UNITED STATES PATENT AND TRADEMARK OFFICE

APPLICATION NO.	FILING DATE	FIRST NAMED INVENTOR	ATTORNEY DOCKET NO.	CONFIRMATION NO.
10/560,415	12/13/2005	German Jauregui	98884.000010	5464
7590 11/06/2008				
King & Spalding Suite 4000 1100 Louisiana Street Houston, TX 77002-5213			EXAMINER GARCIA, ERNESTO	
			ART UNIT 3679	PAPER NUMBER
			MAIL DATE 11/06/2008	DELIVERY MODE PAPER

Office Action Summary

DETAILED ACTION

Fig. 11

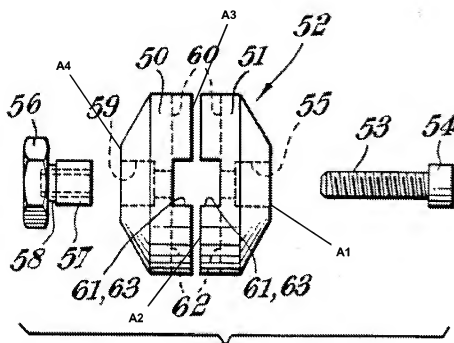
Regarding claim 1, as best understood, Pitt discloses, in Figure 11, a structural connection system comprising at least two of the following members: a closing support member **51**, an off-centered support member, and a vertical support member **50**. The closing support member **51** comprises a piece having any geometry having a top surface **A1**, a bottom surface **A2**, and a diametric channel housing **61**, **63** which extends under the top surface **A1**. The piece incorporates an attachment means **55**. The vertical support member **50** comprises a piece having any geometry having a top surface **A3**, a bottom surface **A4**, and a diametric channel housing **61**, **63** which extends under the top surface **A3**. The vertical support member **50** incorporates an attachment means **59**. The bottom surface **A4** of the vertical support member **50** comprises a male or pin element **57** extending axially.

Regarding claim 2, the closing support member **51** and the vertical support member **50** have a cylindrical shape.
